# Proposed changes to London Luton Airport Arrivals

## CAP1616 Stage 4 Step 4A(i) Consultation Response Document

Figure 18 Action 4: Controlled Airspace Final Design, illustrating the engaged agencies (RAF Wittering is off the map to the northwest)

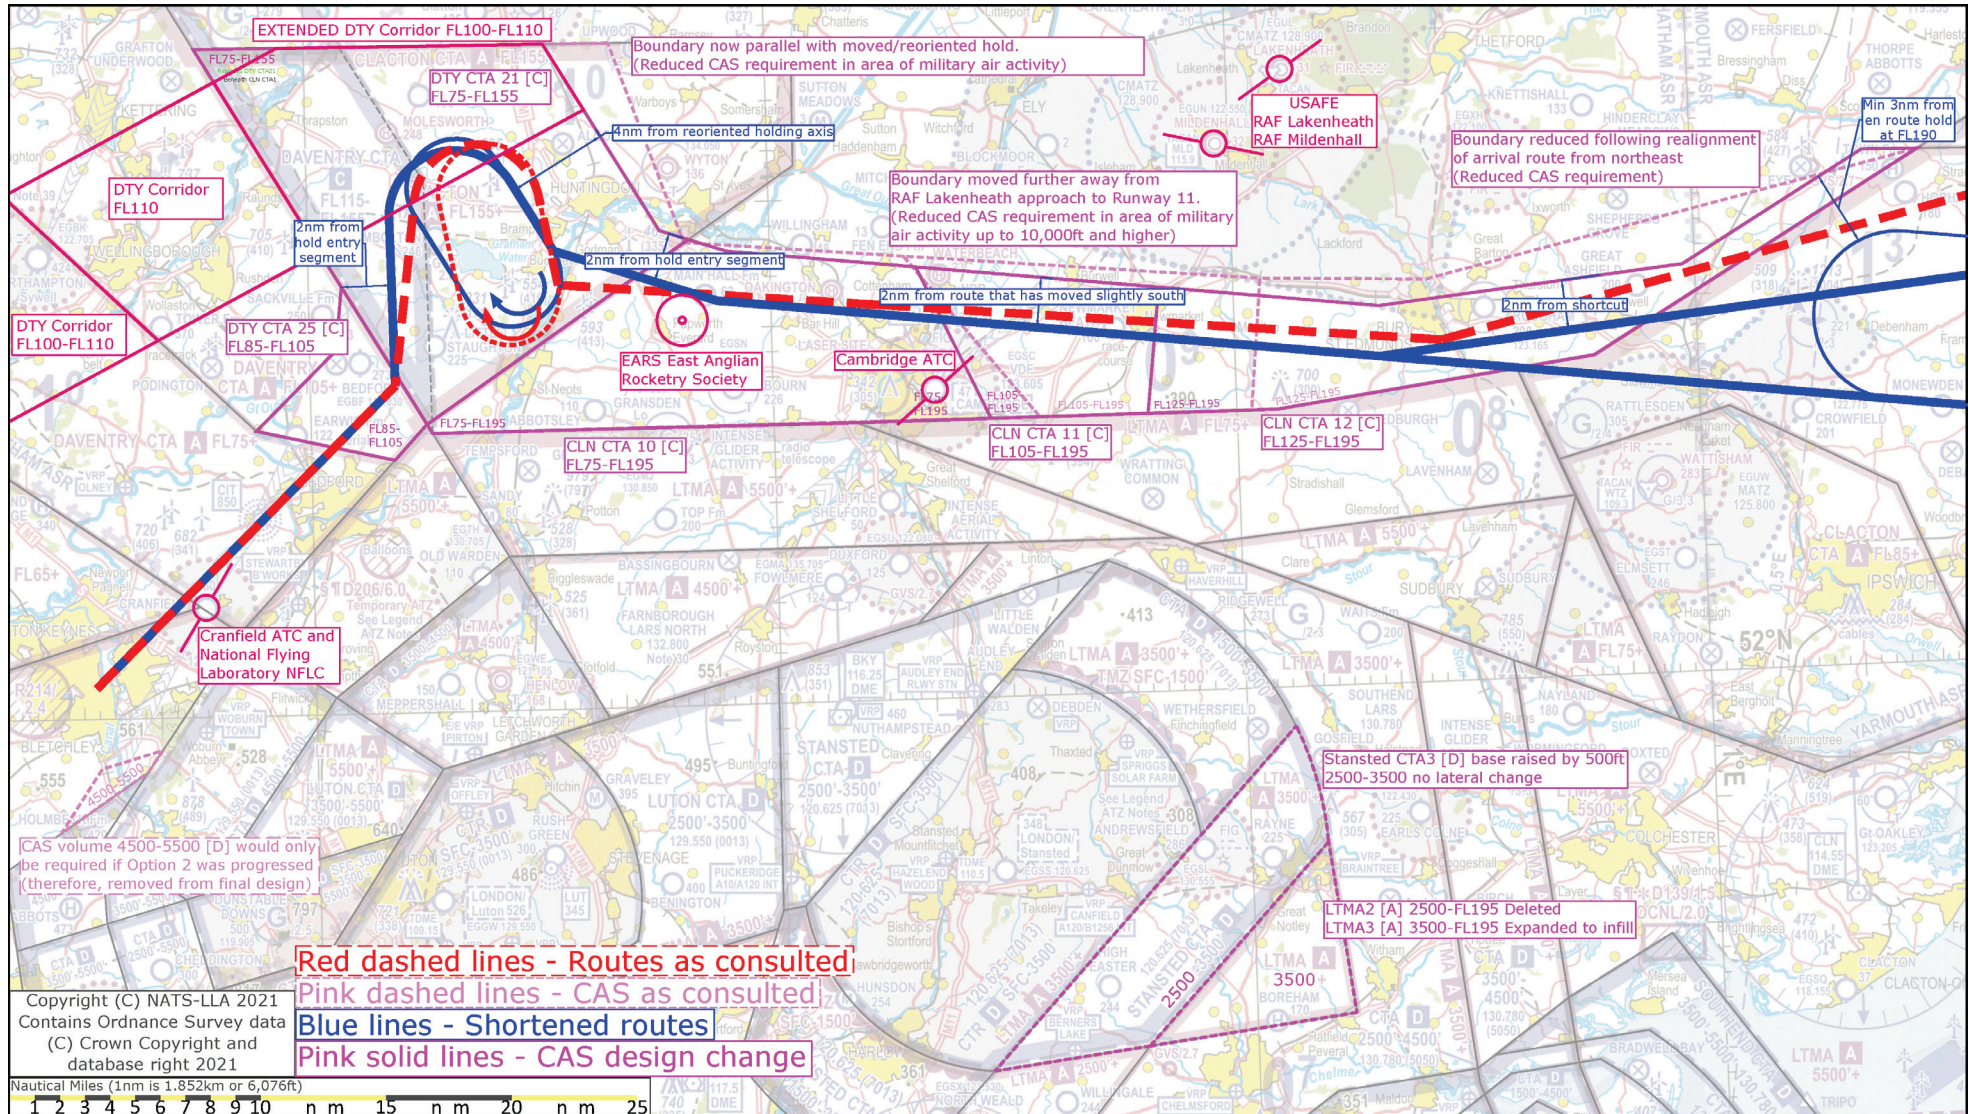
- 9.11.3. As part of shortening the routes (Action 3 Recommendation **3.01**), we have moved the CAS-defining arrival route from the east, shifting it slightly further south and changing its confluence angle at the far northeast. Normally, 3nm CAS containment is required by CAA policy<sup>6</sup> between an RNAV1 STAR and its CAS boundary, however we will provide a safety case to reduce that containment to 2nm. Therefore, moving the route moves the 2nm CAS containment boundary further south, away from the air bases, reducing the impacts on USAFE's operations. We have also reduced the CAS requirement to the northeast, and ensured at least 3nm CAS containment against the moved en route hold at FL190.

9.20. Figure 18 on the next page shows the Final Design CAS, illustrates some of the construction notes, and compares it against the consulted-upon design Option 1.
